Office Action Summary

10/723,446

LOUTHAN ET AL.

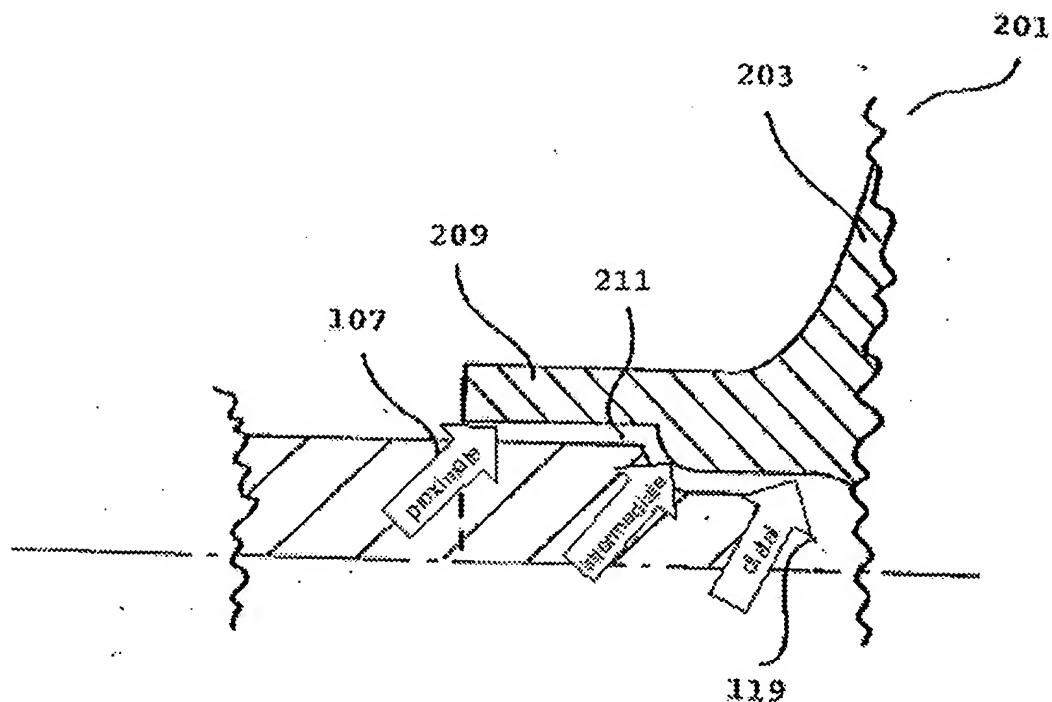
Claims 1-2, 4-5, 7-8, 10, 12-14, 17-18, and as far as claim 9 is definite, are rejected under 35 U.S.C. 102(e) as being anticipated by United States Patent Application Publication No. 2005/0036893 (Decker hereinafter).

Decker teaches a compressor wheel comprising: titanium (see paragraph 0029); a proximate end; a distal end; an axis of rotation 111; a plane positioned between the proximate end and the distal end; and a joint 119 having an axis coincident with the axis of rotation and an end surface positioned between the plane and the distal end. See annotation on the following page.

Due to the location of the joint 119, the peak principle operational stress of the compressor wheel inherently occurs proximate to the end surface and proximate to the axis of rotation and does not exceed the yield stress.

The joint 119 is capable of receiving a compressor shaft wherein the end does not extend beyond the plane.

The compressor comprises a shaft 107 positioned in the joint 119, whereby said shaft has a distal end that does not extend beyond the plane.
